CORRECTION(S) TO WATER WELL RECORD (WWC-5)

Saline Co RWD No 8_2010

To "CAIseman@laynechristensen.com"
<CAIseman@laynechristensen.com>
cc Dennis M Bowman <dbowman@bwrcorp.com>,
"vincentbrad@hotmail.com" <vincentbrad@hotmail.com>,
Dan Clair <dclair@kdheks.gov>, Dave Waldo
bcc
Subject FW: Variance Request - Revised, Project PW004454 Saline
CO RWD # 8

Re: Variance Request – Grout Surface Seal Depth
Revised per discussions w/ Bob Vincent / Paul Bodner

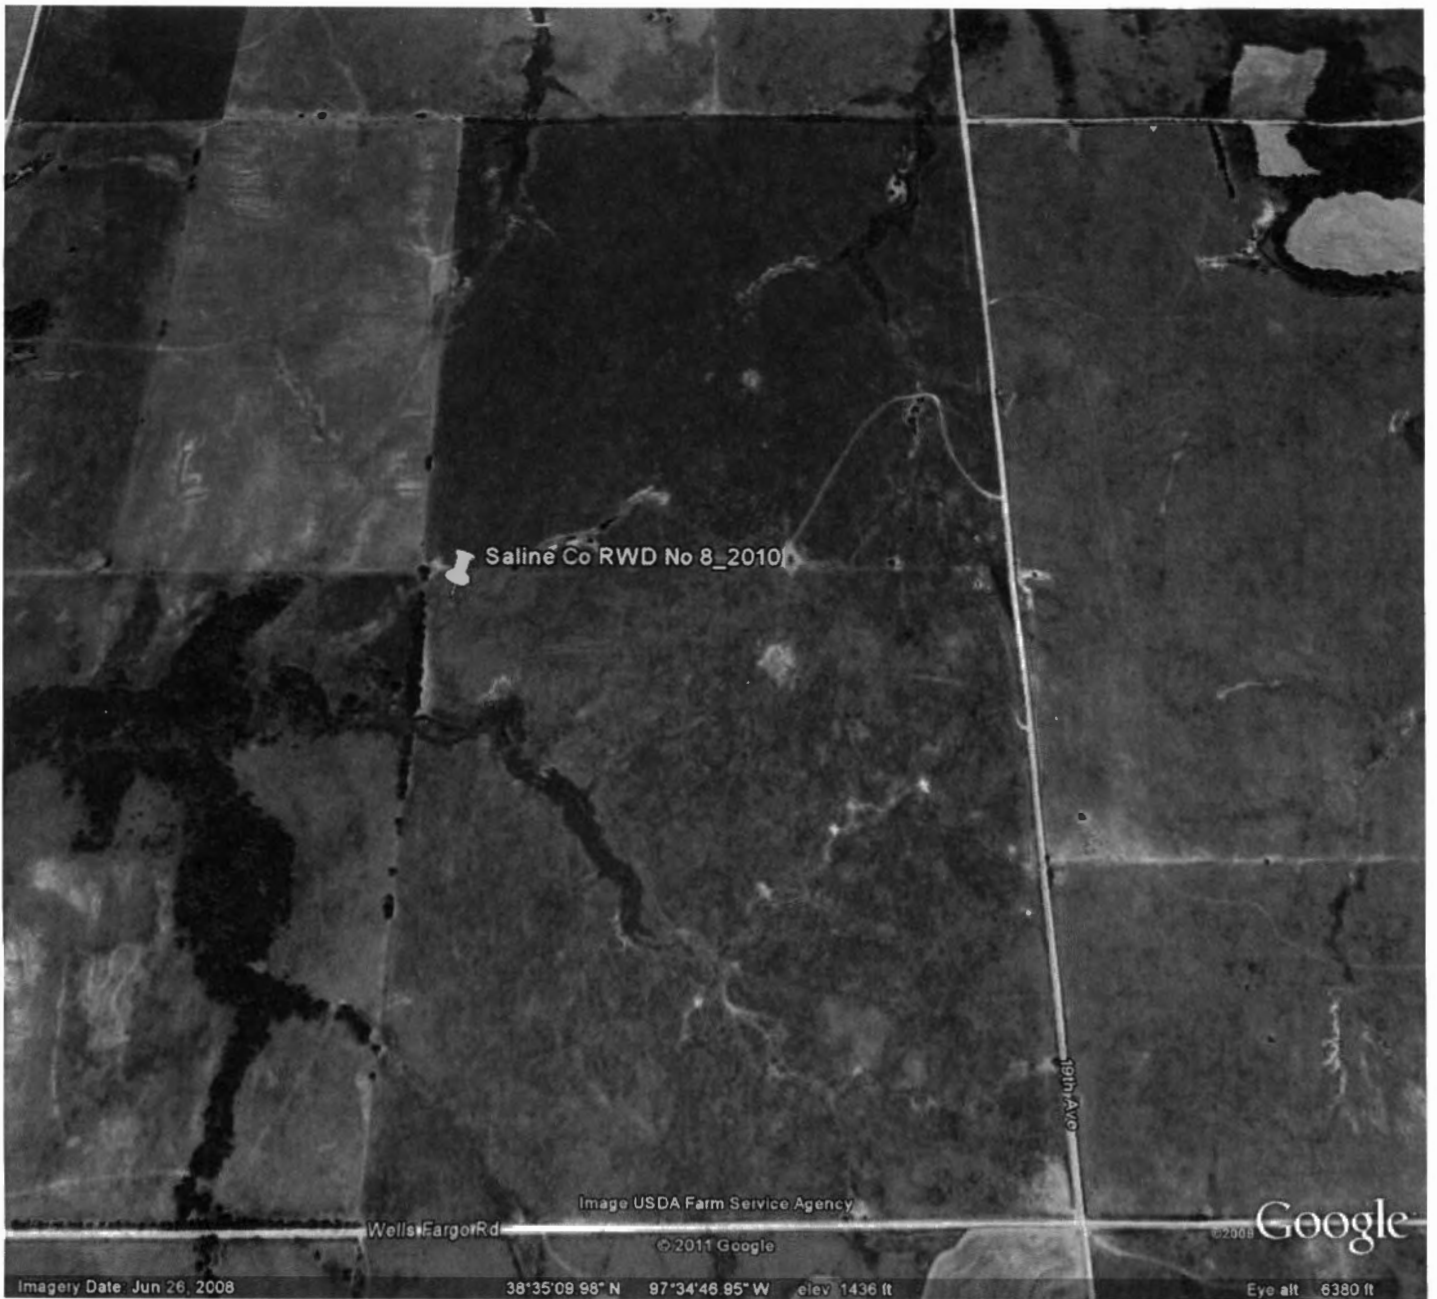
Location listed as:

Location ~~changed to:~~

Other changes: Initial statements: Saline County

7-17.5-2 W

NW NW NW SE

Changed to: McPherson County
